Re: Trans Mountain Pipeline ULC ("**Trans Mountain**")
Trans Mountain Expansion Project ("**TMEP**" or "**Project**")
File OF-Fac-Oil-T260-2013-03 60
**Section 211 Deviation Application for PPBoR Sheets M002-PM03011-014 and
M002-PM03011-015**

2. The revised detailed route ("**Revised Route**") is shown on the revised PPBoR Sheets attached as Appendix A and the location of the Revised Route in relation to the approved detailed route ("**Approved Route**") is illustrated in the maps attached as Appendix B. The Revised Route is entirely within the corridor approved by Certificate of Public Convenience and Necessity ("**CPCN**") OC-065.

DRAWING NUMBER	SHT. NO.	REV.
M002-PM03011	014	2

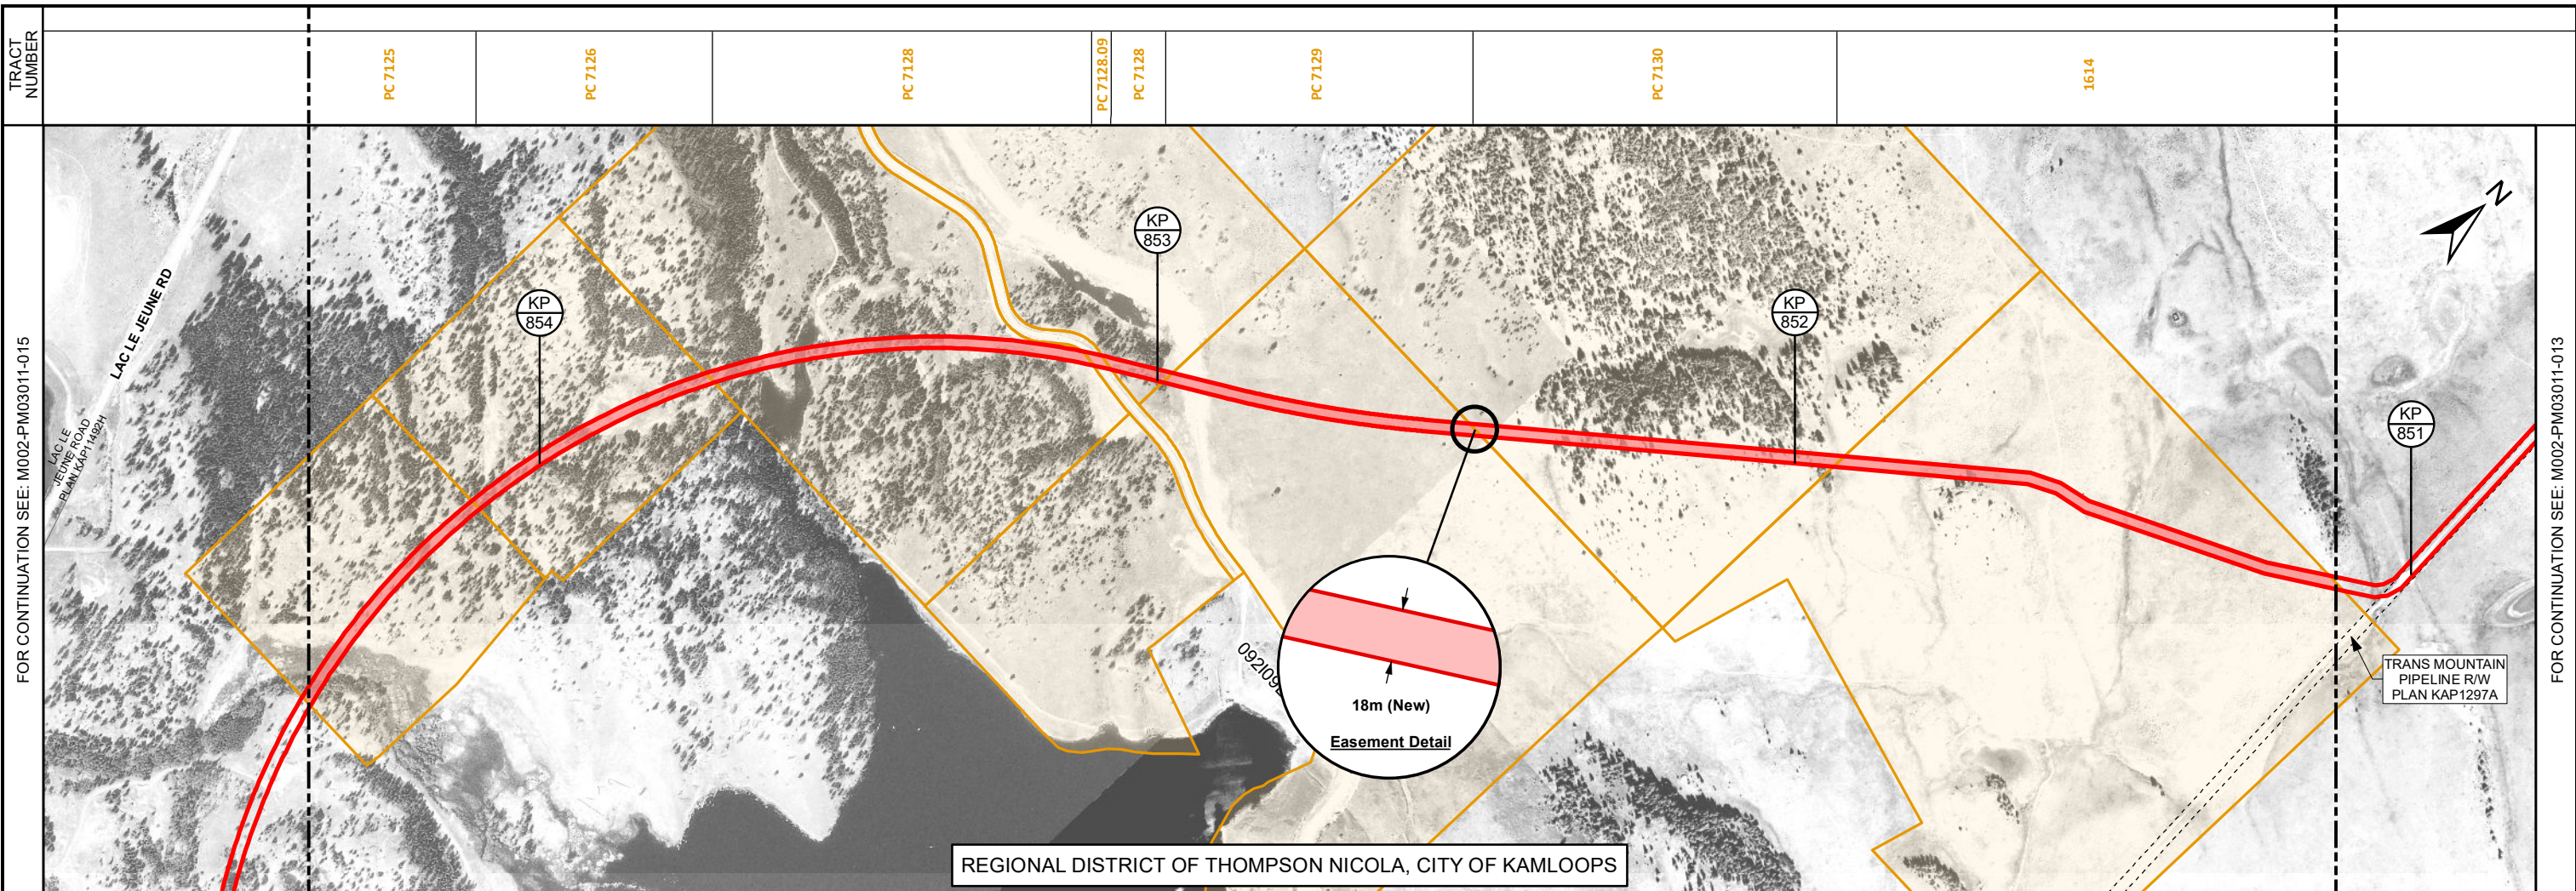
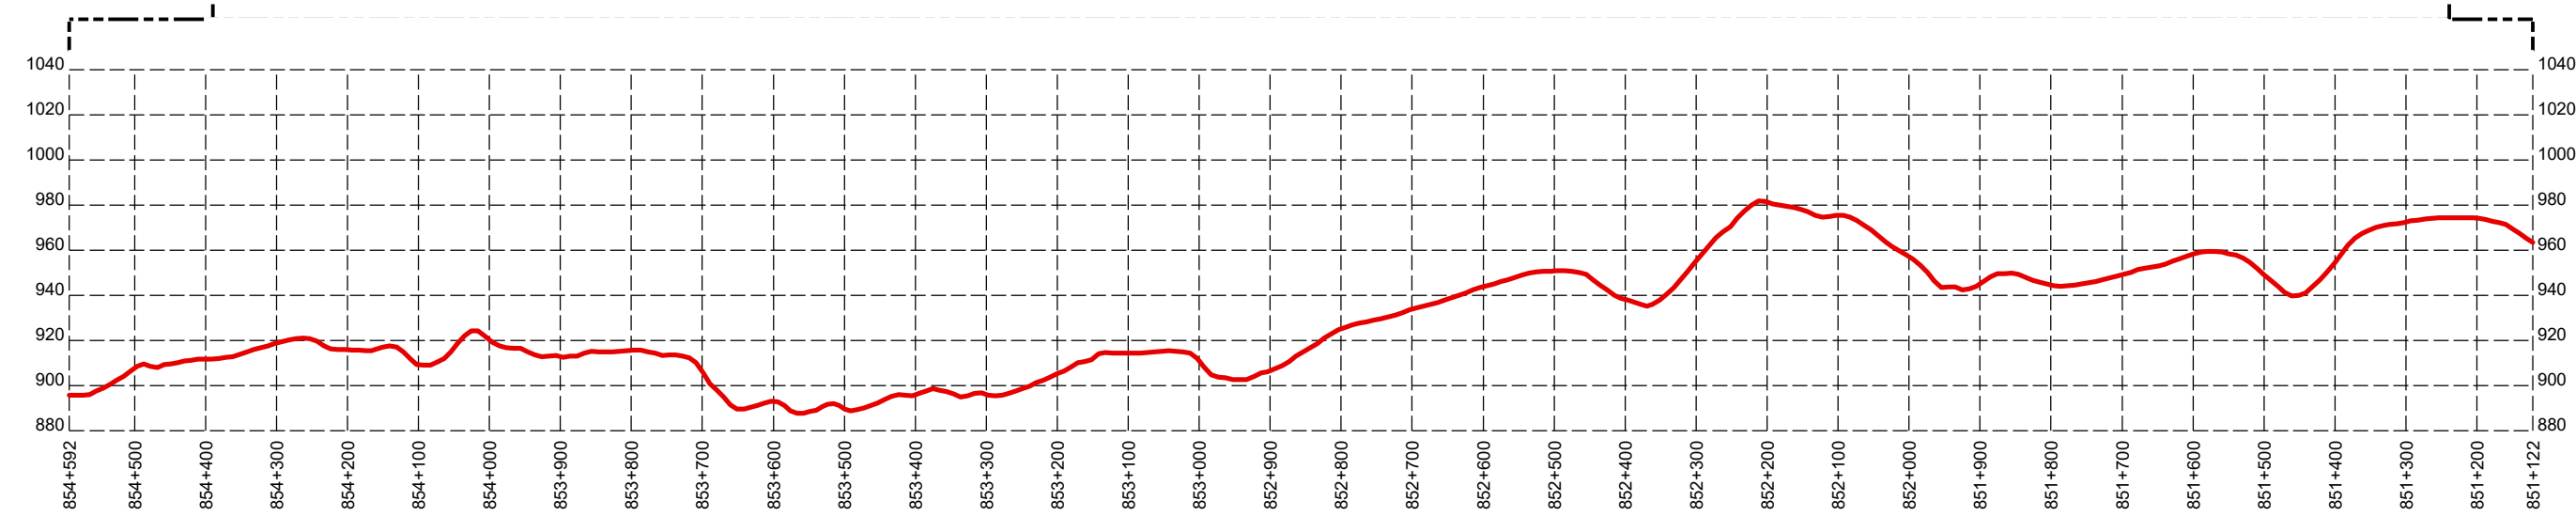
11. Trans Mountain and SSN have collaboratively developed a construction methodology and associated routing that seeks to minimize surface disturbances at Pipsell, including Jacko Lake and surrounding areas, which hold spiritual and cultural significance to SSN based on this engagement.

12. Between May and August 2021, Trans Mountain assessed the feasibility of various trenchless construction methodologies for the Lands and engaged with SSN on options. Based on this assessment, Trans Mountain has determined that the most appropriate construction methodology for the Lands to address SSN's concerns is microtunneling. As shown in the attached Appendix B, the Revised Route incorporates revisions to the right of way for the TMEP to accommodate the change in construction methodology from conventional open trench to microtunneling. Trans Mountain anticipates that the proposed microtunnel will minimize surface disturbances on the Lands. In January 2022, SSN consented to the Revised Route and the proposed construction methodology and confirmed that they address SSN's concerns.
